RE: Abatement Plans
NOV N84-2-13-1

Abatement Plans NOV N84-2-13-1

Basin to Control Slurry Line Discharges

U. S. Steel Corporation
Wellington Coal Cleaning Plant
ACT/007/012, Carbon County, Utah

WELLINGTON COAL CLEANING PLANT
PROPOSED SLURRY DISCHARGE
LOCATION MAP

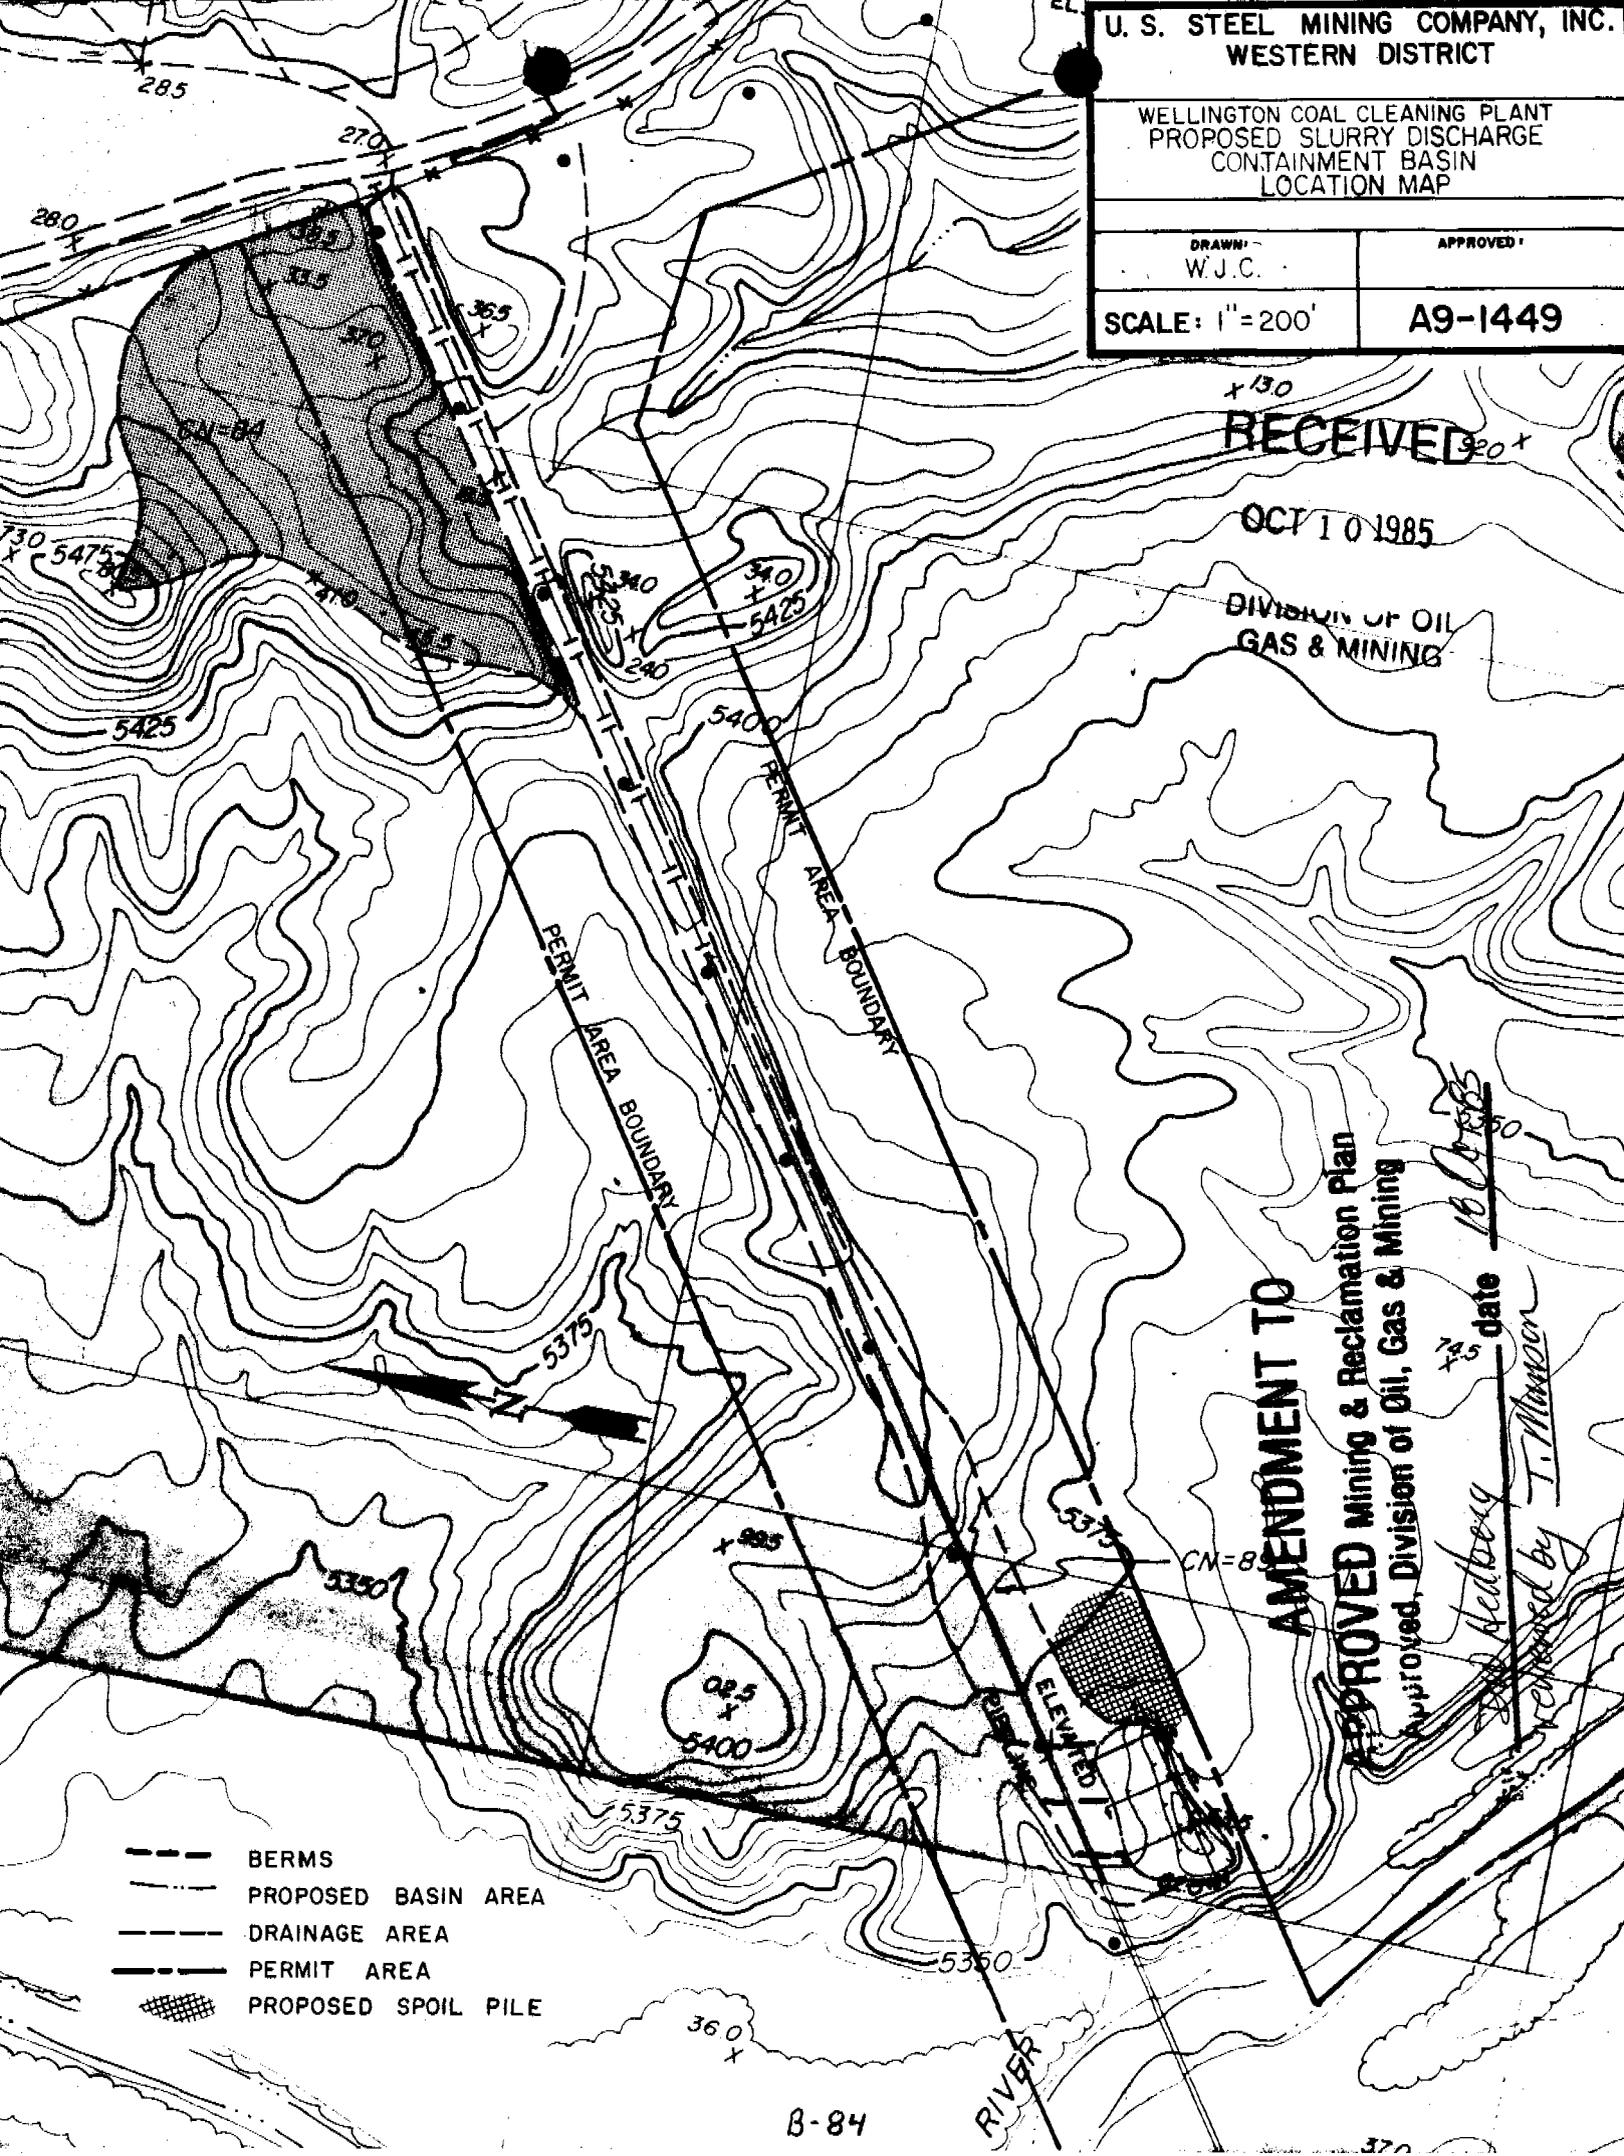
The proposed modifications will be conducted in an area which was previously disturbed as was noted in the original submittal. Therefore, it will not be necessary to salvage and store topsoil. Spoil from the pond excavation will be stored as shown on map A9-1449.
